**Subject** ▶ Change on housing, etc.

**For Models** ▶ 6903VD/VDW (Cordless Impact Driver)

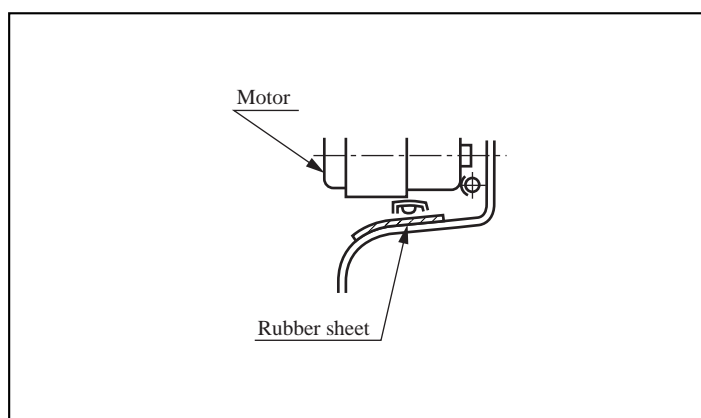
**Description** ▶ 1. The quantity of vents in the housing will be increased.

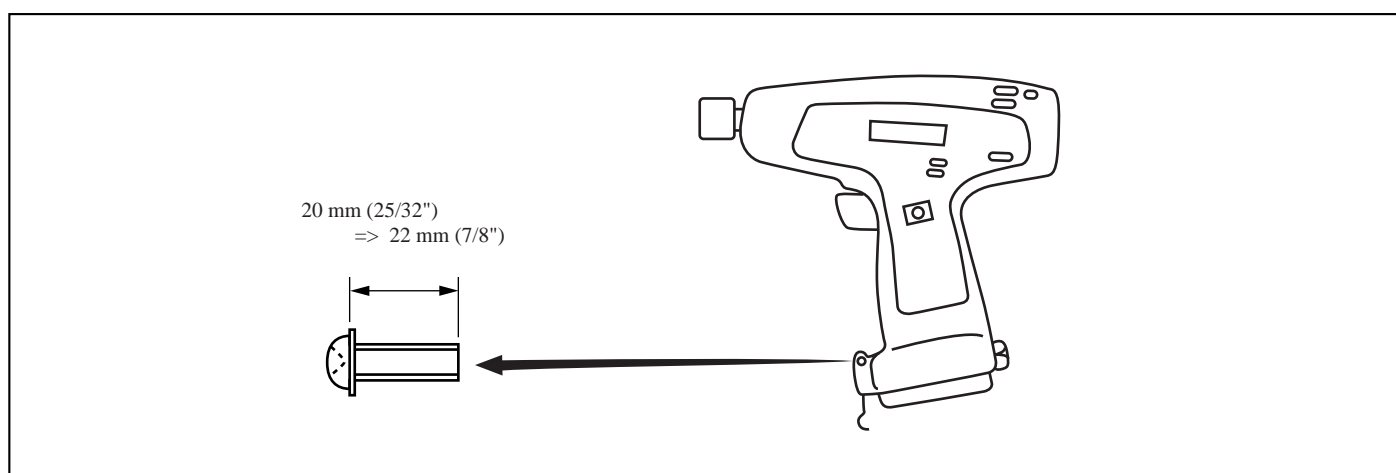
2. The rubber sheet (constituent part of housing) under the motor will be discontinued.
